LECROY S.A	
NAME	MODEL: PS1724
DATE	4 OUTPUTS, REMOTE SENSE
REV	REV. NO. SCHEMA-PS1724
DATE	10-10-91
BY	1 OF 2 REV. 1 A

ECO 1000:

LeCroy S.A	
DESIGN	MODEL : PS9370
QUOTE1-0	AUXILIARY POWER SUPPLY
ORD	
LECRMW-0	DWG NO: SCHEMA-PS9370
DATE	SH: 1 OF 1 REV: 0
01-02-96

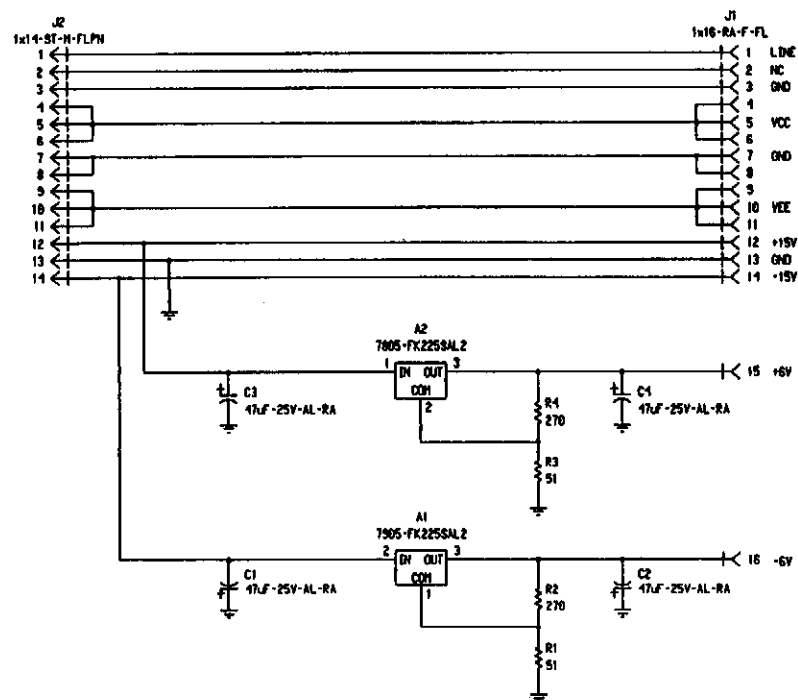
Replace connector J2 (1x14-ST-M-FLPN)
by new connector J2 (1x3-ST-M-FLPN)

J2 Pin 12 = New J2 Pin 1
J2 Pin 13 = New J2 Pin 2
J2 Pin 14 = New J2 Pin 3

ECO 1000:

Replace connector J1 (1x16-RA-F-FL)
by new connector J1 (1x5-RA-F-FL)

J1 Pin 12 = New J1 Pin 1
J1 Pin 13 = New J1 Pin 2
J1 Pin 14 = New J1 Pin 3
J1 Pin 15 = New J1 Pin 4
J1 Pin 16 = New J1 Pin 5
